CITY PLANNING COMMISSION

PROPOSAL: The applicant is requesting the necessary entitlements to develop an 18,000± square foot office complex consisting of the Dutra House and two new buildings in the LPPT-PUD (aka Riverlake)

APPLC. NO. P88-311 MEETING DATE September 8, 1988 ITEM NO. 15

EXHIBIT A

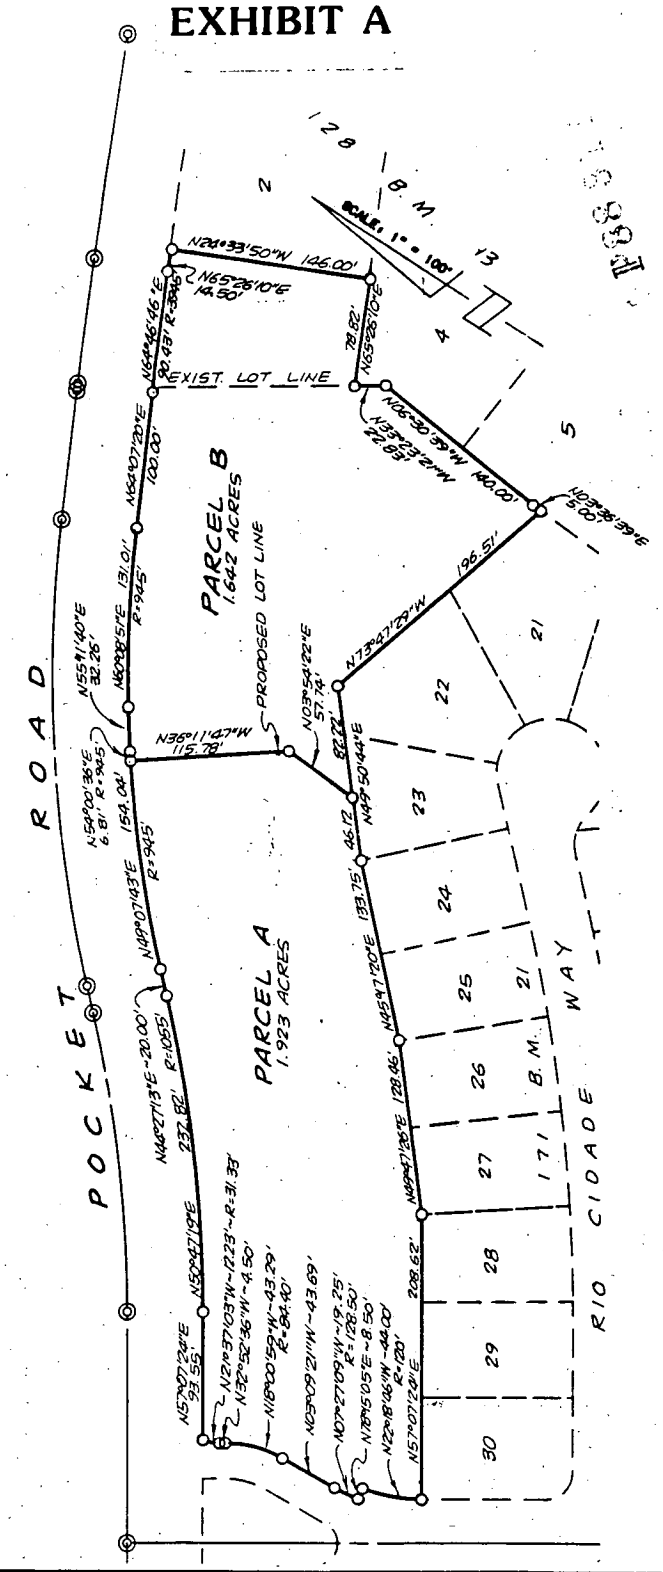
The applicant is requesting a lot line adjustment to relocate the common property line to the west in order to create the subject site. The proposed

adjustment has been reviewed by the City Engineering, Transportation, Planning and Real Estate Divisions. There were no objections to the lot line adjustment request.

H. Approve the Lot Line Adjustment by adopting the attached resolution.
